Log # TXX-89616
File # 10010
913.2

SUBJECT: COMANCHE PEAK STEAM ELECTRIC STATION (CPSES)
DOCUMENT NOS. 50-445 AND 50-446
ADVANCE FSAR SUBMITTAL
ADDITIONAL CHANGES TO THE CPSES OPERATING ORGANIZATION
FSAR SECTION 13.1

Advance FSAR Change Related CPSES Operating and Support Organizations
and
Supporting Documentation

FIGURE 13.1-3

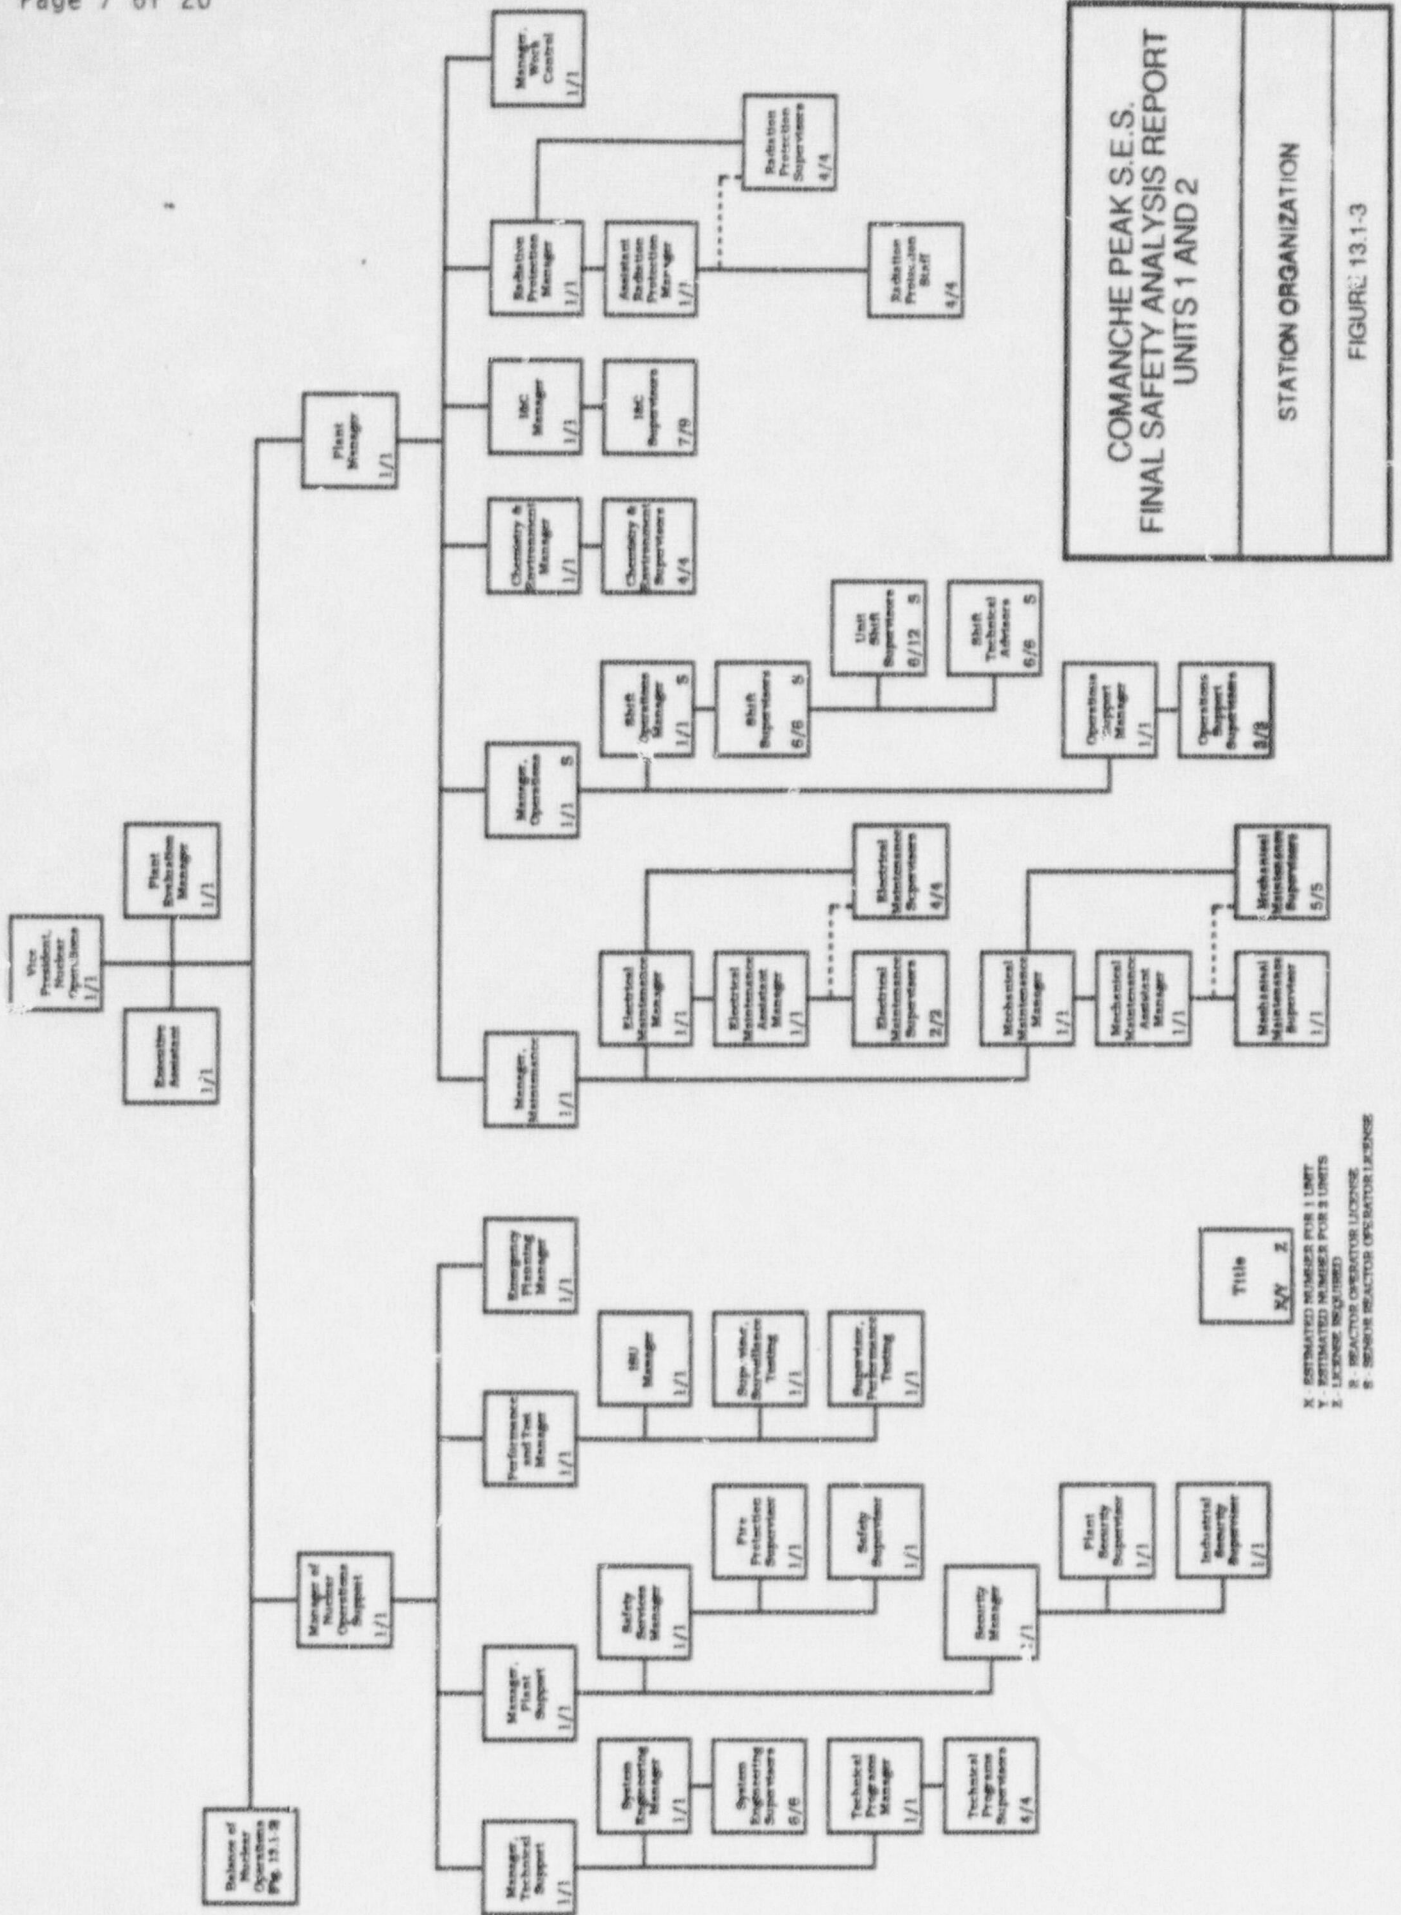
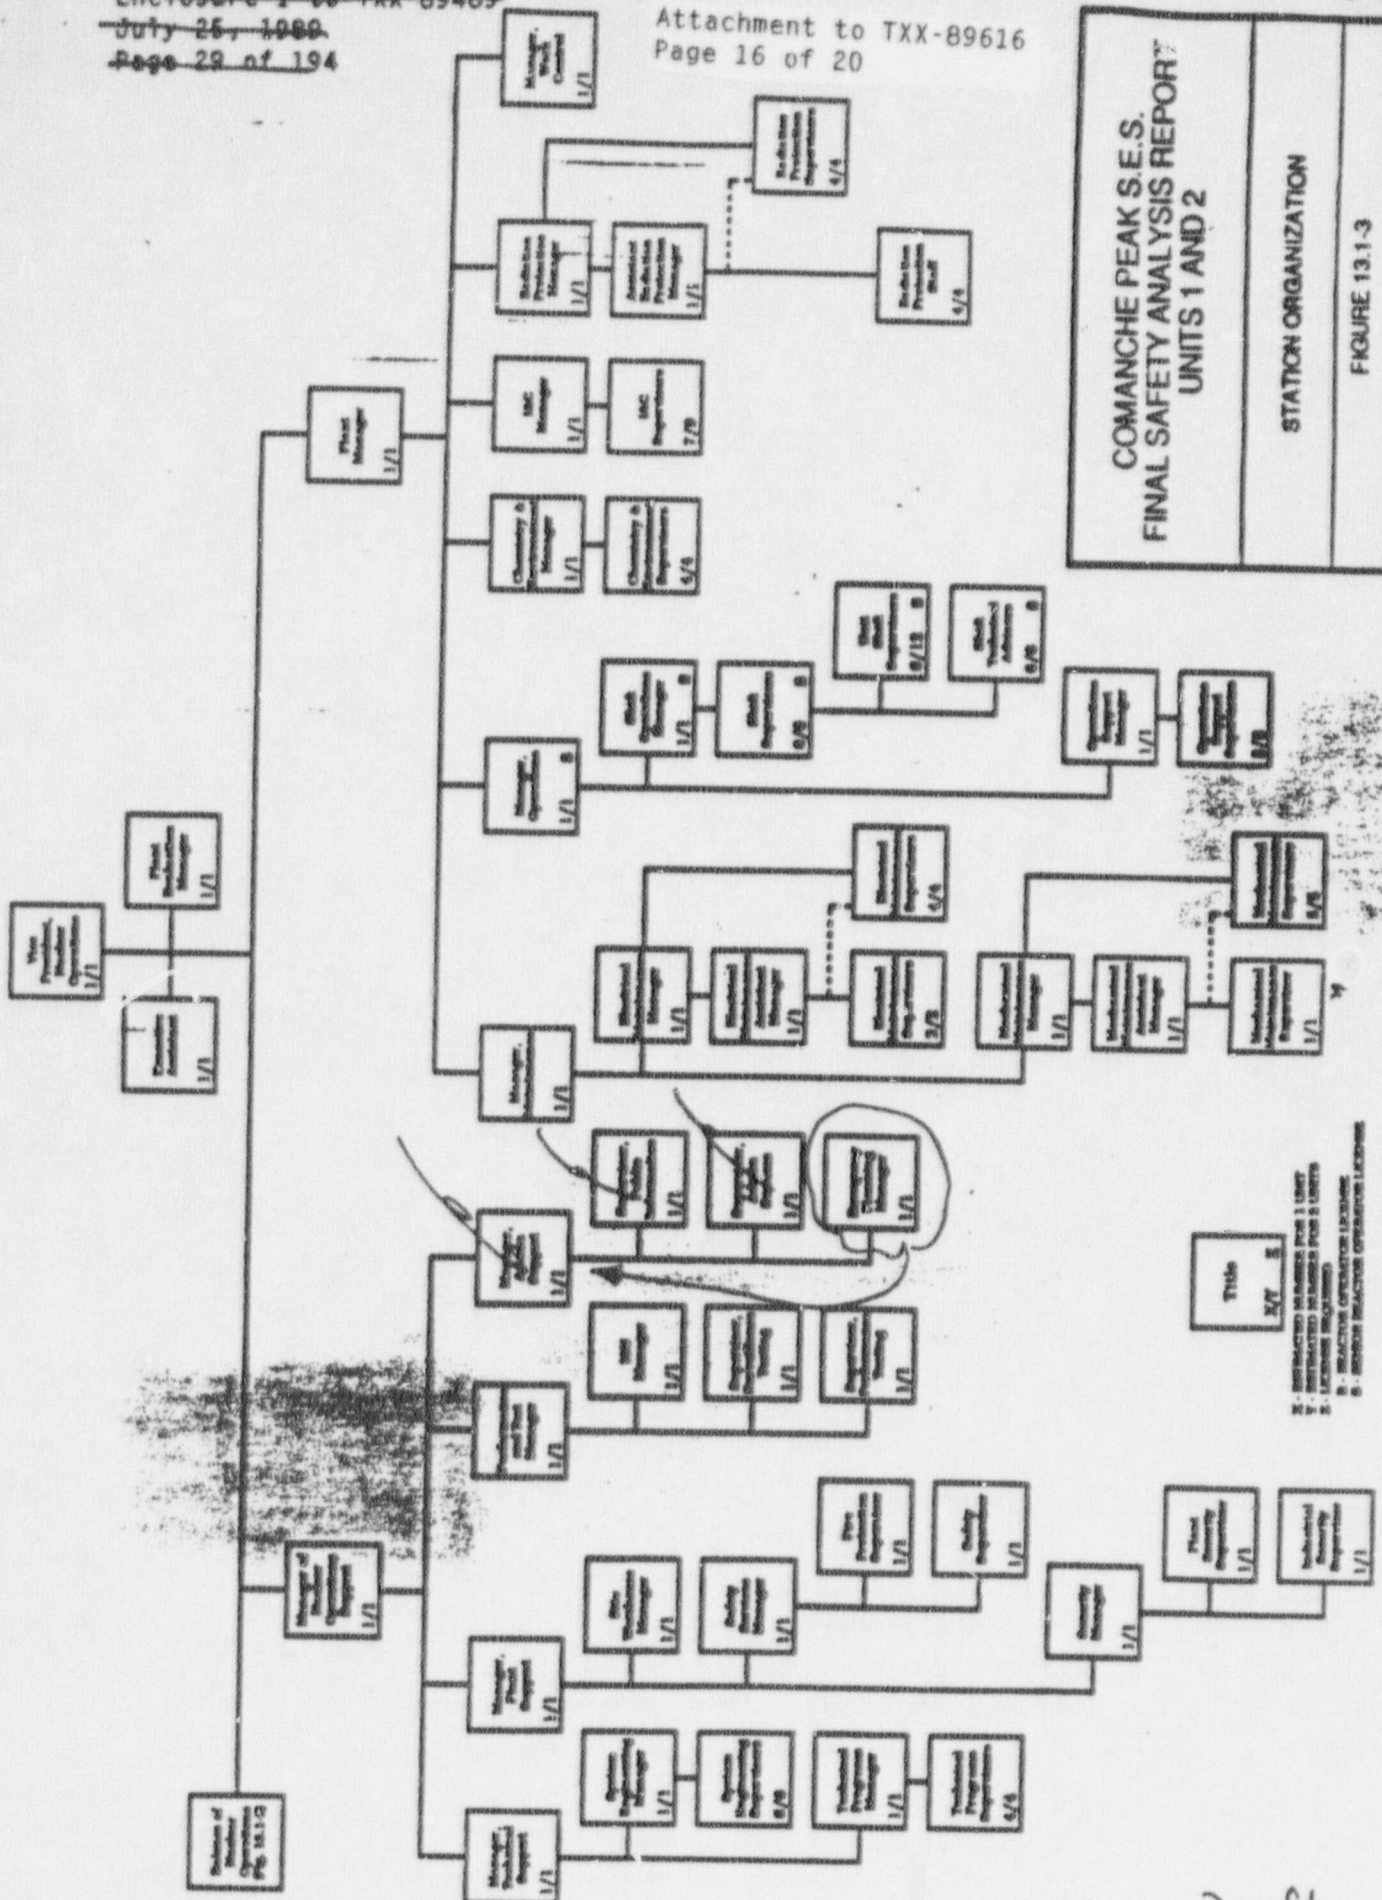
| Figure 13.1-3 | 4 | Update to CPSES operating organization pertaining to administrative support functions.

Revision:
Align FSAR with present CPSES operating organization and reflect recent organizational changes.
FSAR Change Request Number: 89-609
Related SER Section: 13.1; SSER6 13.1
SER/SSER Impact: No |

Proposed change: This figure has been revised to reflect these previously discussed organization changes.
